**SUBJECT: OYSTER CREEK GENERATING STATION (OYSTER CREEK)
OPERATING LICENSE NO. DPR-16
DOCKET NO. 50-219
RESPONSE TO REQUEST FOR ADDITIONAL INFORMATION -
RADIOLOGICAL CONSEQUENCE ANALYSIS FOR CONTROL ROOM
OPERATORS AT OYSTER CREEK GENERATING STATION
(TAC NO. MA3465)**

RESPONSE TO REQUEST FOR ADDITIONAL INFORMATION

Figure 1
Integrated Aerosol Mass Leaked Out Through One Inboard MSIV
(No Collection DF Being Applied)

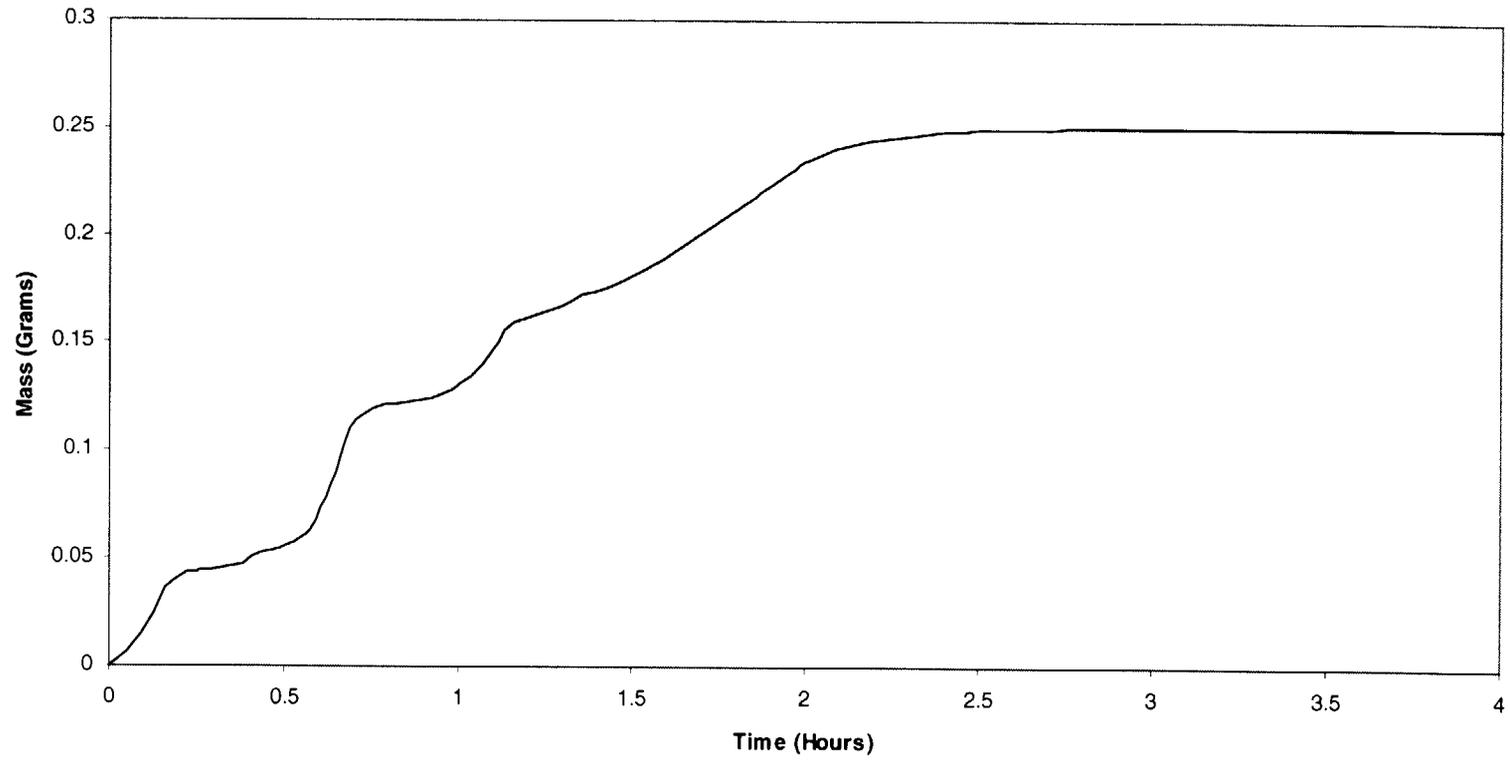
8. NRC Question

- Provide detailed technical justifications and references used for estimating aerosol impaction (decontamination factor of 2) at the inboard main steam isolation valve (MSIV) in the steam line with one open MSIV; and
- Describe in detail the STARNAUA model used for estimating aerosol sedimentation between the other steam line's closed MSIVs and provide the aerosol removal coefficients calculated with STARNAUA.

Using the above expression with the most conservative value for K , the leak path would be plugged when $5.9\text{E-}3$ grams of aerosol has leaked through the single orifice. On Figure 1, which represents the mass leaked out through one MSIV as a function of time without plugging being considered, one can see that the total leaked mass per MSIV would be about 0.25 grams if plugging were neglected. Therefore, the actual effective DF due to leak path plugging would amount to about 40 (i.e., 0.25 grams/0.0059 grams). It is noteworthy that the leak path would be plugged very early into the event, as $5.9\text{E-}3$ grams of aerosol would have leaked through the hypothetical MSIV leak orifice in only 180 seconds.

The effect of plugging would be greater than just a DF for the aerosol release; it might actually affect the rate of gaseous iodine and noble gas release, as well. These effects are ignored, however. Instead, only a DF of two on the aerosol (and on the elemental iodine which is assumed to be adsorbed on the aerosol is credited (Reference response to NRC Question No. 4).

These results show that despite some conservative assumptions, the decontamination factor that could be credited due to impaction at the inboard MSIVs could be greater than 40. Therefore, crediting a DF of two for the Oyster Creek inboard MSIVs is justified.
